Re: 94 4th St. CPD
DCI2024-00024

Please accept the following information in response to your July 30, 2024 correspondence regarding the above referenced project:

94 4th Street CPD
DCI2024-00024

**MASTER
CONCEPT
PLAN**

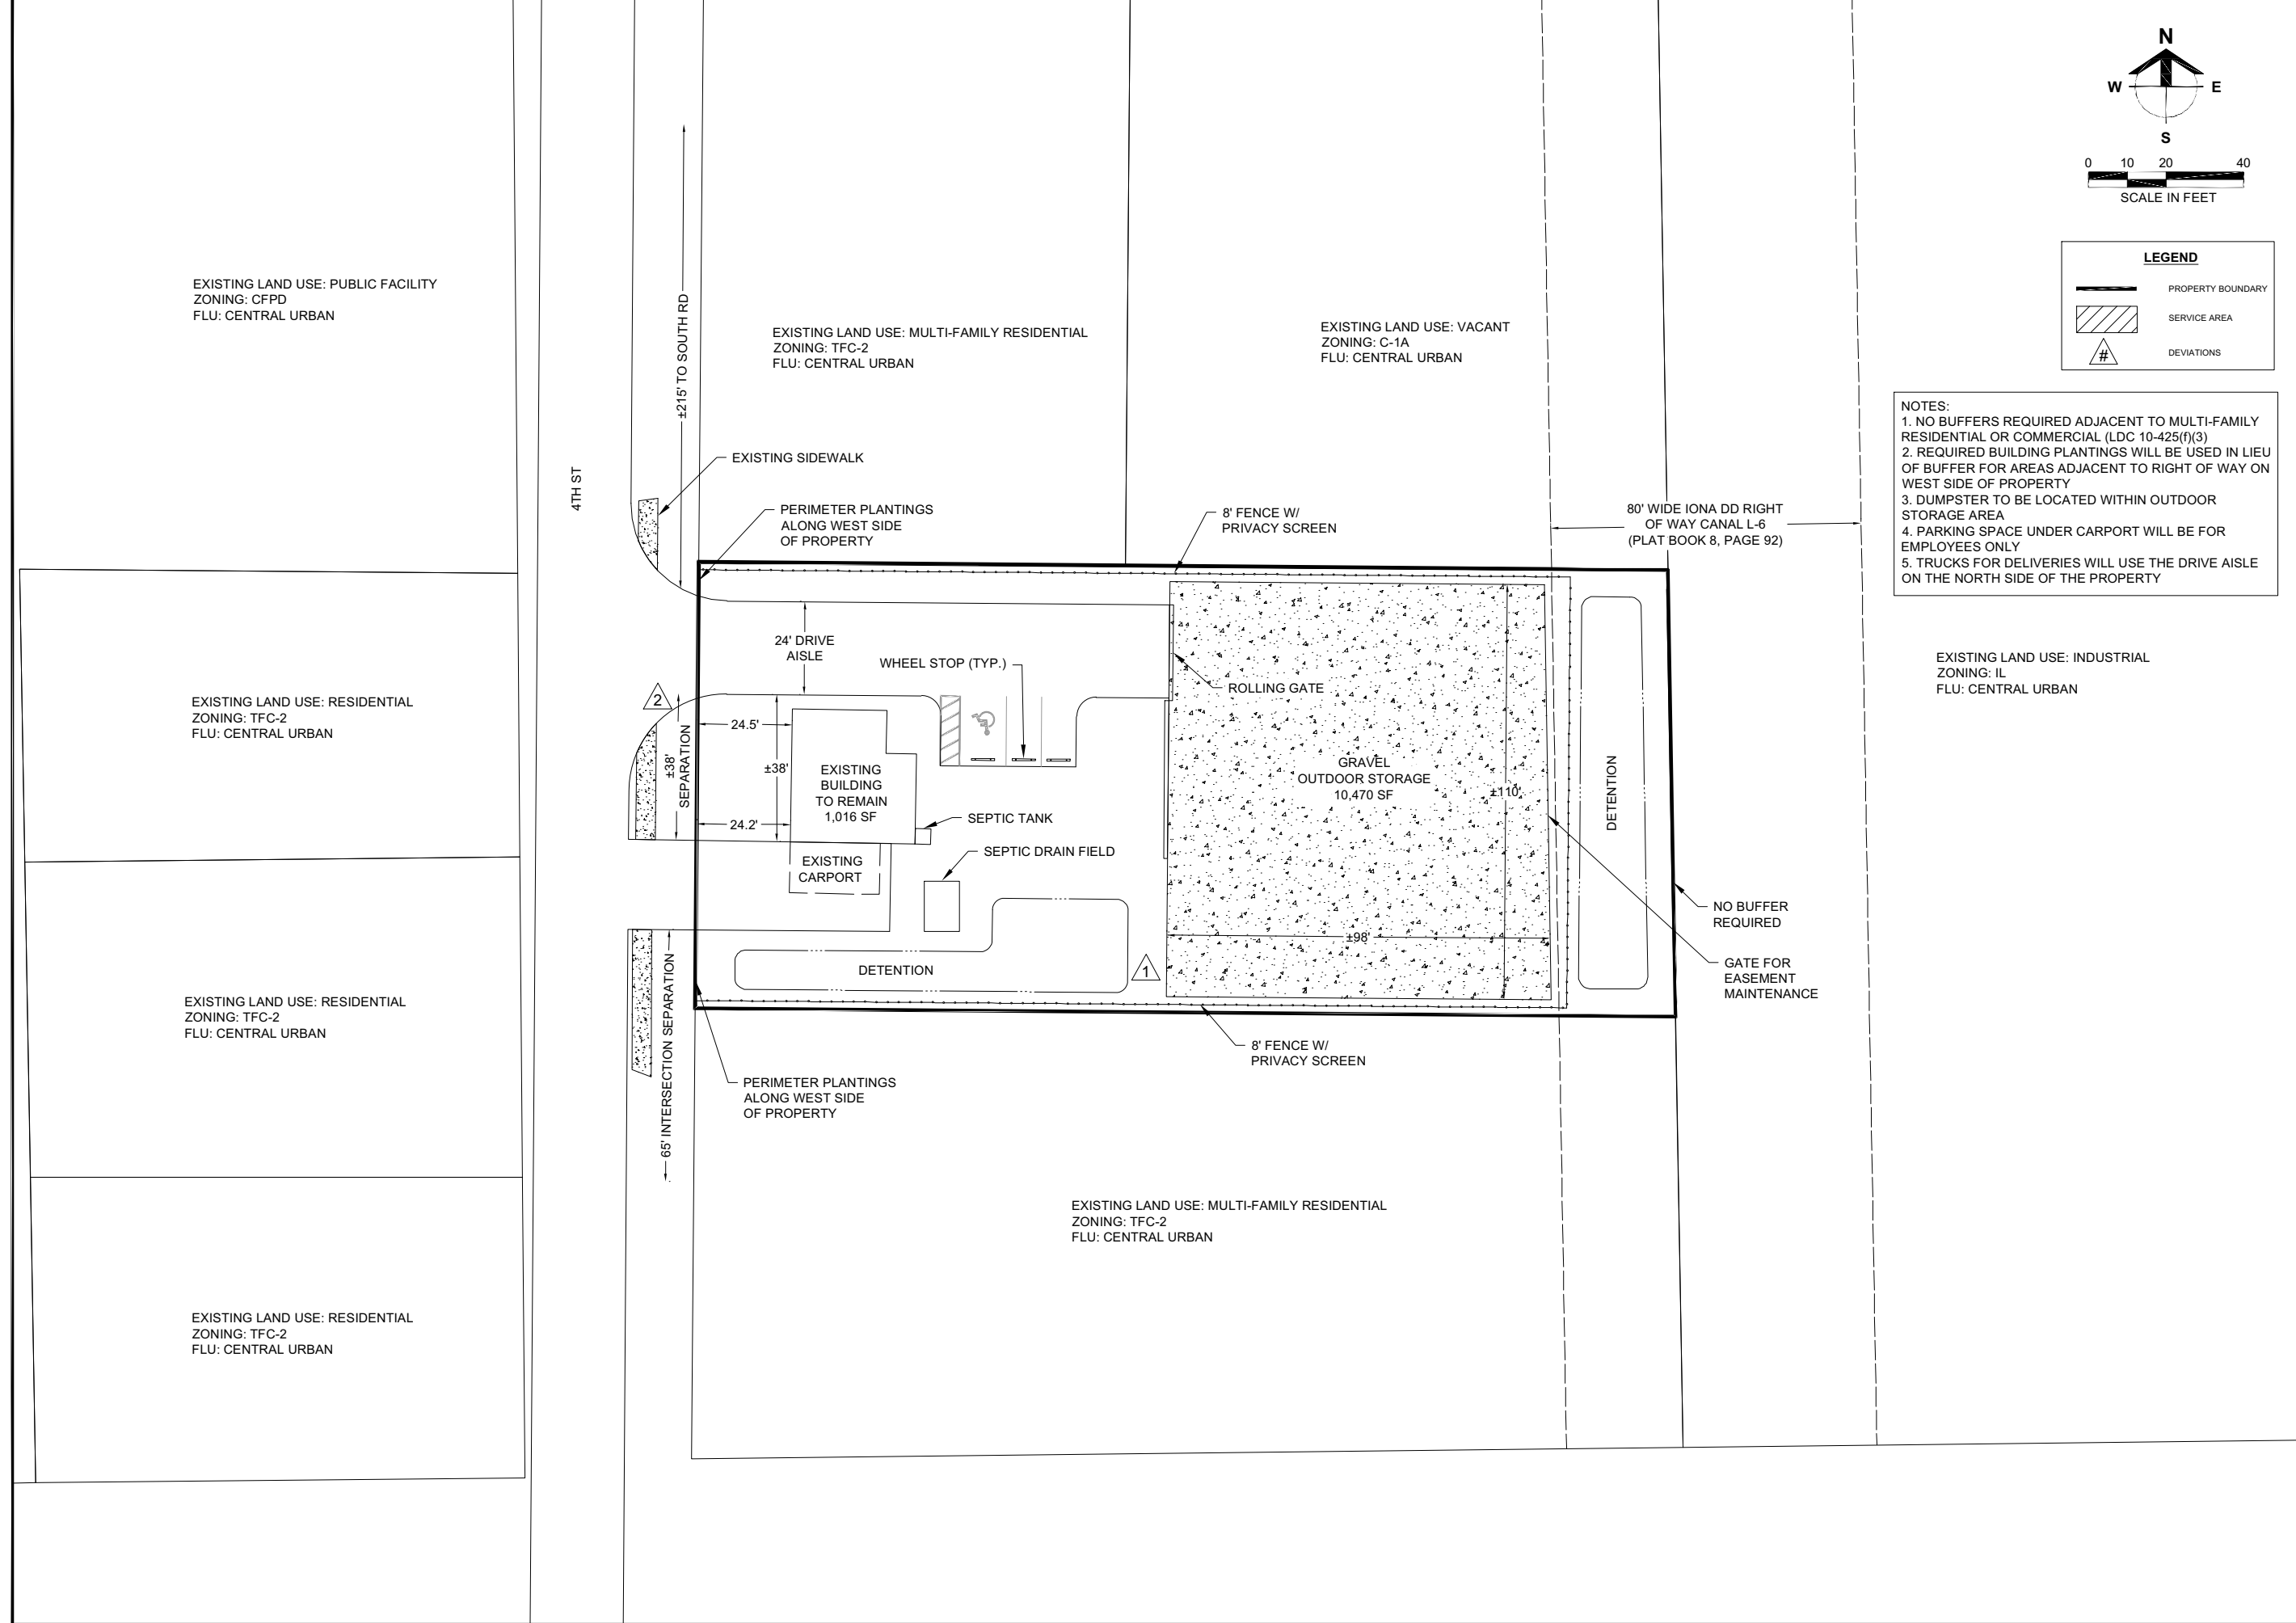
1. The Master Concept Plan must depict the location and explanation of all existing easements, whether those easements are recorded. If an easement is based upon a recorded document, the official records book reference must be stated. Please revise accordingly.

2. The general location of service areas for delivery of goods or services must be shown for all developments that are not residential subdivisions. Please revise accordingly.

Revise the Master Concept Plan to provide right-of-way buffer. Indicate if building perimeter plantings will be utilized to meet the buffer requirements as stated in LDC Section 10-425(f)(1).

Revise the Master Concept Plan to depict all utility, drainage, and right-of-way easements. No required landscaping must be proposed in any drainage, utility, or right-of-way easements per LDC Section 10-421.

Deviation #3 must be revised. The Mixed-Use Overlay (LDC Section 10-425(f)) and Open Storage (LDC Section 34-3005(b)) are the two codes for the buffer requirements. Revise the deviation to cite these requirements where applicable. The north buffer must be ten-foot-wide abutting the residential use and no buffer is required abutting the commercial use per code. The south property line abuts multi-family, which requires no buffer per LDC Section 10-425(f). It is unclear where the applicant is proposing enhancements versus deviations because incorrect codes are being utilized.

Sec. 34-2016(3) Parking aisle width. The minimum two-way aisle width for 45 degree parking is 22 feet. The proposed MCP indicates an aisle width of 20.15 feet, which does not meet this requirement.

Please revise the MCP to remove all code-required trees and shrubs from IDD drainage and maintenance easement.

The Master Concept Plan shows the only easement, which is the 80-foot wide Iona Drainage District right-of-way of canal L-6.

The Master Concept Plan has been revised accordingly.

The Master Concept Plan has been revised accordingly. Building perimeter plantings will be utilized to meet LDC requirements.

The canal right-of-way is shown at the eastern end of the property. It is acknowledged that landscaping cannot be placed in any drainage, utility, or right-of-way easement.

The Master Concept Plan and narrative have been revised to comply with Sections 10-425 (f) and 34-3005 (b) of the LDC. A buffer is not required on the north side since the surrounding property contains multi-family residential.

The MCP has been revised and the parking will be located in the back of the structure and LDC requirements will be met.

The Master Concept Plan has been revised accordingly.
